RotorSport UK Ltd

Service Bulletin

SB No.: 016 issue 2	CCAR No.: None	Classification: OPTIONAL or RECOMMENDED or MANDATORY
Aircraft type & model (applicability) RotorSport UK MT-03	Aircraft serial Nos. effected RSUK/MT-03/all

The MT-03 series gyroplane pilot enclosure is retained to the airframe via several fastening points, two of which are via short metal straps at the lower rear of the enclosure. The straps are welded to the airframe, and one has been found to have broken free in service due to vibration.

Picture of replacement bracket (RH shown)

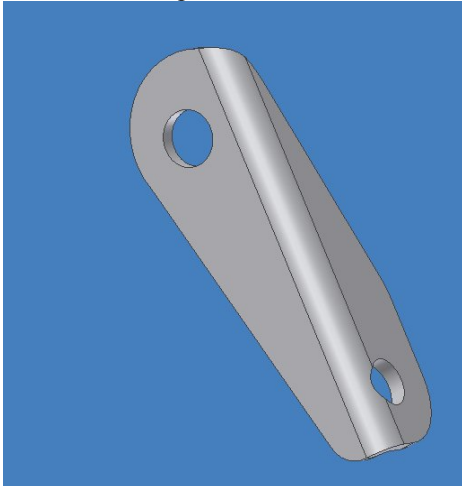
1. Remove ignition key and isolate engine starter solenoid
2. Chock wheels.
3. Remove existing broken bracket, and carefully grind off any broken remains. Offer up new clamped bracket RSD3045 RH (or 3046 LH) to the Enclosure (see photo) so that the 6mm hole aligns with the hole indicated below, and the flat side is nearest the enclosure.
4. Clamp bracket to suspension bow cross tube with the M6 button head bolt, washers, and nylock nut (screw head uppermost, and bracket under the flange).
5. If required, adjust the bracket by bending so that the hole lines up with the enclosure.
6. Refit fastening between the enclosure and bracket.

- 1 x RSD3045 Bracket RH and/or
- 1x RSD3046 Bracket LH
- 1 x RSD6008 Nylock nut
- 1 x RSD6057 M6 x 15 button head screw
- 2 x RSD6024 M6 plain washer
